INDESIT company

Model type:
LI680PLUS

Commercial code:
F037869

N1045136FIG1

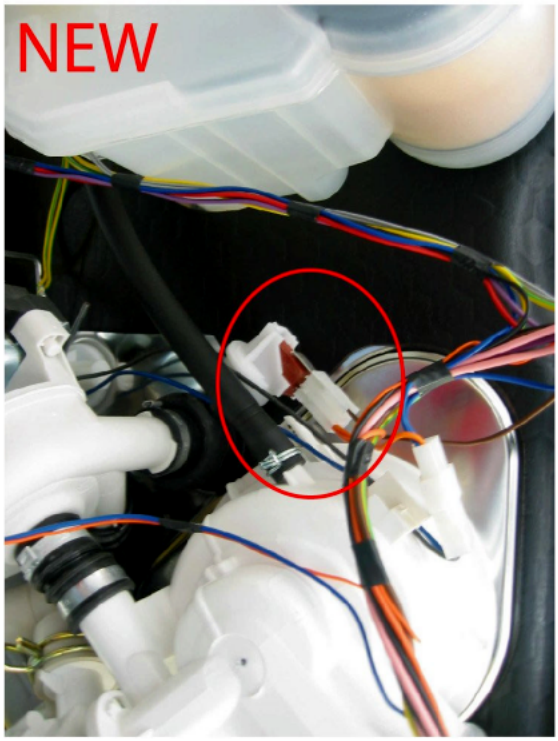
In modified products the connector going to the high pressure sensor is part of the wiring assembly (see picture N1045136FIG1).
In premodification products the high pressure sensor is connected to the wiring assembly by a cable that is part of code C00094157 (see pictures N1045136FIG2-3).

New parts
Wiring
C00142435 - high pressure sensor

The new parts are not individually interchangeable with premodification ones.
